**SITE PLAN: LOT 345, PHASE 4,
THE PARKE AT OCEAN PINES, SECTION 16,
THIRD TAX DISTRICT, WORCESTER COUNTY, MARYLAND**

WORCESTER CO ZONING REVIEWED

Worcester County Critical Area Reviewed
By: S. Wilson

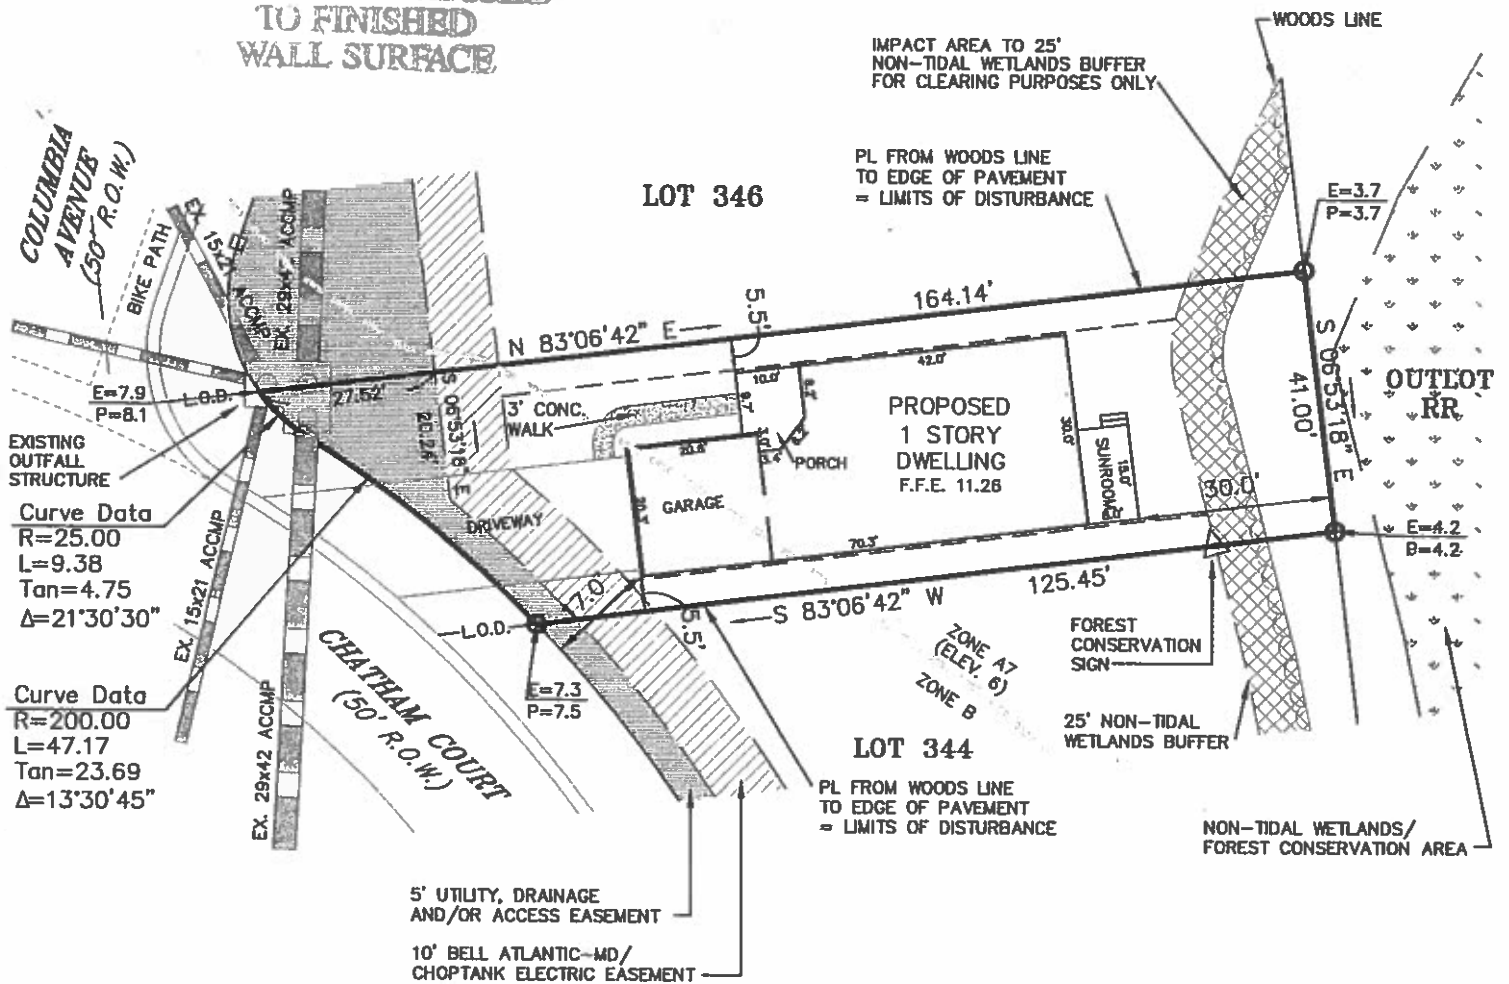
COMMENTS: Trial P311 S16 L345
BPH #83339 SFD, Commerant
sunroom, garage right
SWM/SEC #83338

Comments: SWM #83338

satisfies "10% rule"
